Modification to Minister's Approval

Application Number:	MP 06_0228
Proponent:	Shoalhaven Starches Pty Ltd
Approval authority:	Minister for Planning
Project:	Shoalhaven Starches Expansion Project
Date of original approval:	29 January 2009
Modification:	MP 06_0228 MOD 9 – Packing Plant

Noise Barrier Walls

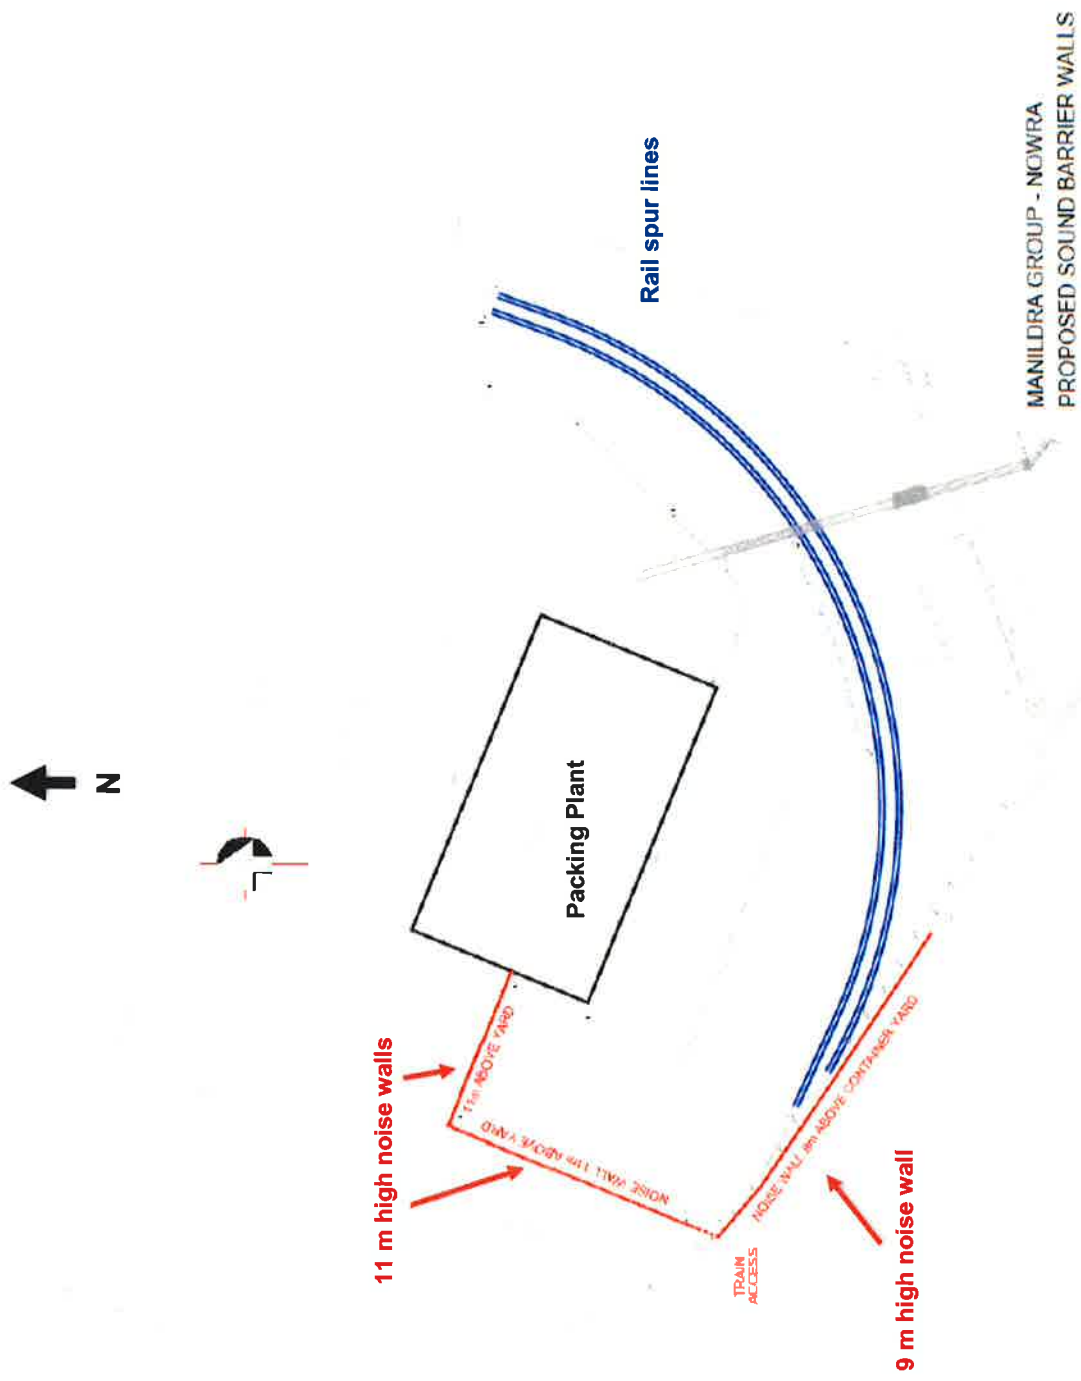
- e) permanent sound barriers a minimum 11 m high relative to the finished ground level of the container storage yard. Barriers shall extend along the entire length of the north-western boundary of the container storage area, connecting to the packing plant along the north-eastern boundary (see the figure in Appendix 2I);

- f) permanent sound barriers a minimum 9 m high relative to the finished ground level of the container storage yard, along the south-western side of the rail spur lines, as shown in the figure in Appendix 2I; and

- g) sound barriers shall be constructed as solid masonry walls, or other equivalent material, without holes or gaps, other than a maximum of 50 mm at the base.

Location of Building Openings

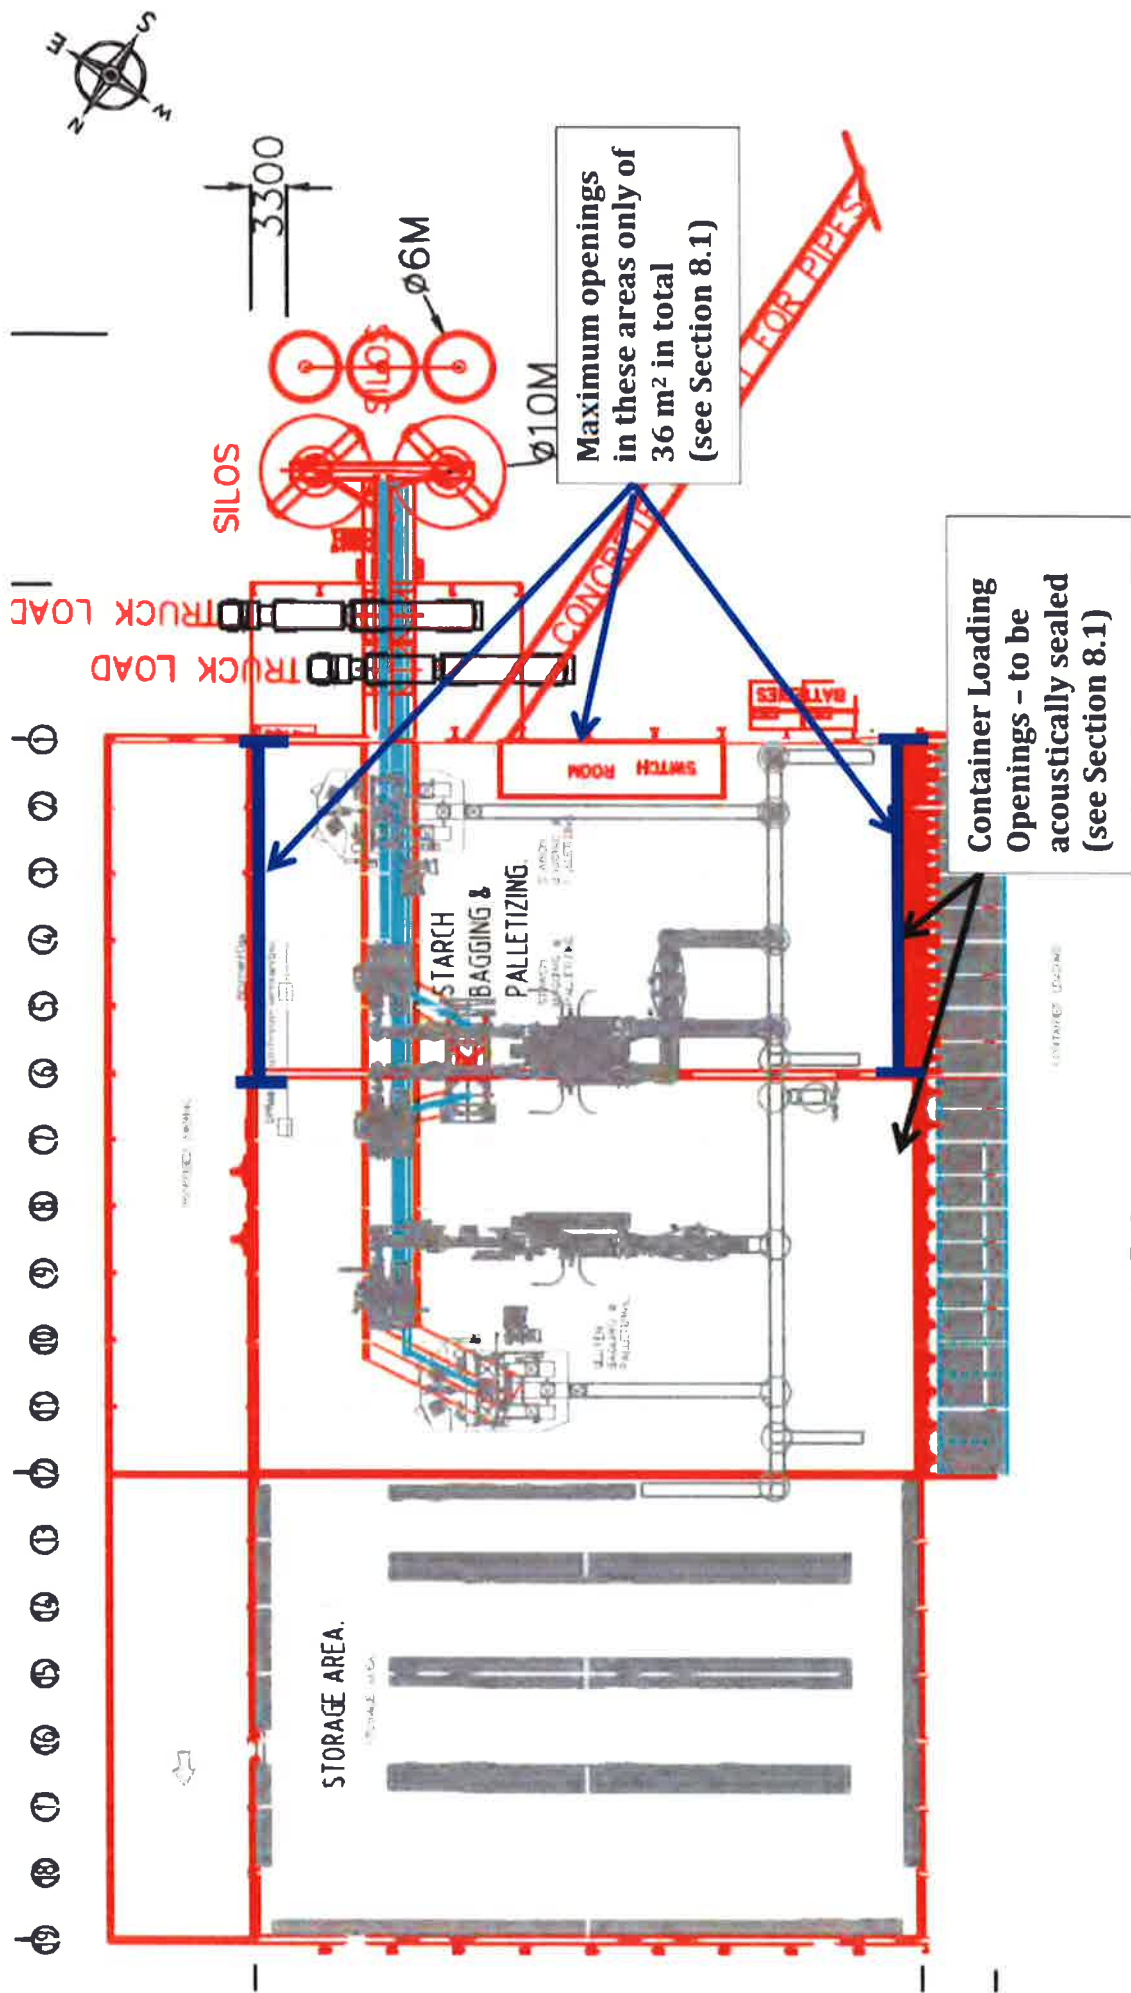
- b) all external doors are a minimum 44 mm thick, solid core timber construction, or equivalent material, in well-sealed frames;
- c) building openings without acoustic treatments shall not exceed 36 square metres and shall be located in the south-eastern part of the packing plant building, as shown in Appendix 2I;

Under-bore pipes under Bolong Road

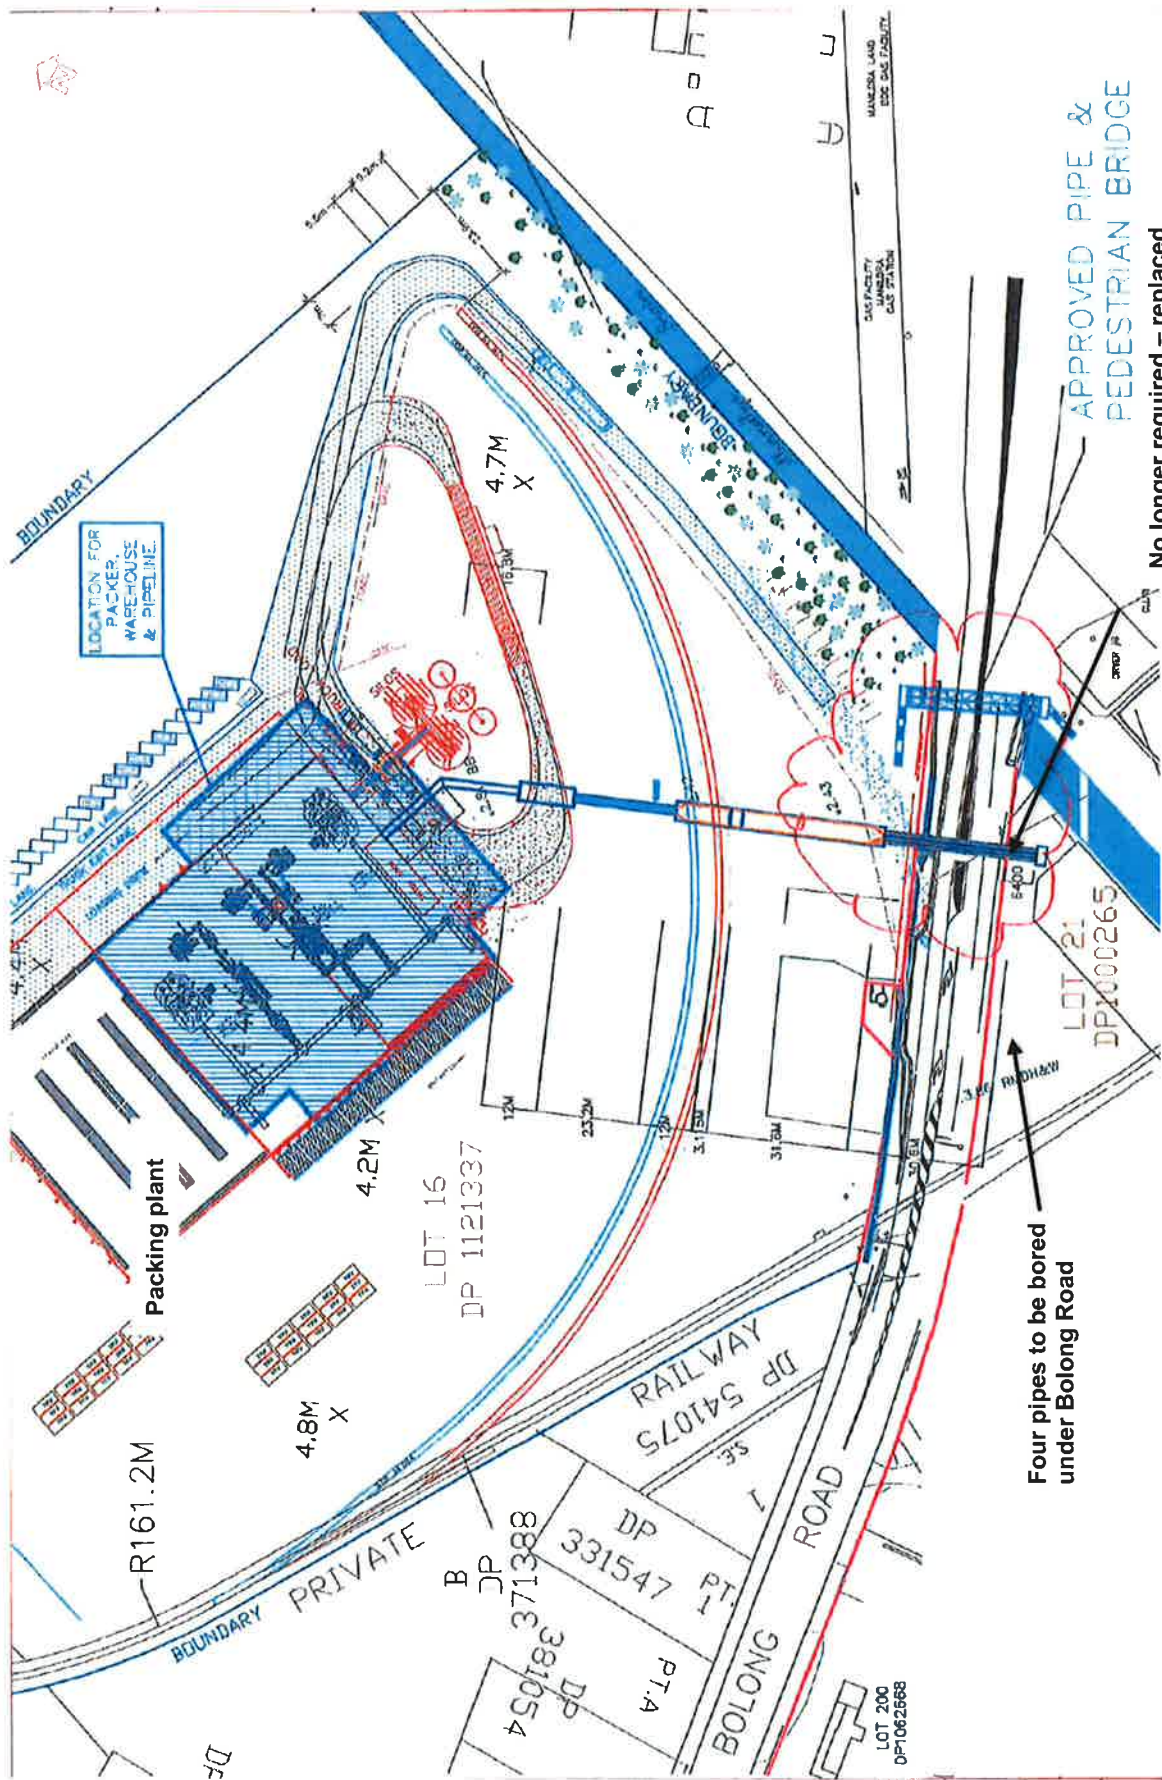
- 10A. The Proponent shall:
 - a) consult Telstra and Jemena during preparation of detailed design for the under-boring of pipework under Bolong Road as described in MOD 9;
 - b) contact Telstra and Jemena at least two weeks prior to the commencement of the under-boring works;
 - c) ensure that mechanical excavation or boring works are undertaken in accordance with the requirements of Telstra and Jemena in order to protect the private infrastructure assets; and
 - d) complete restoration works to the ground surface and footpath.
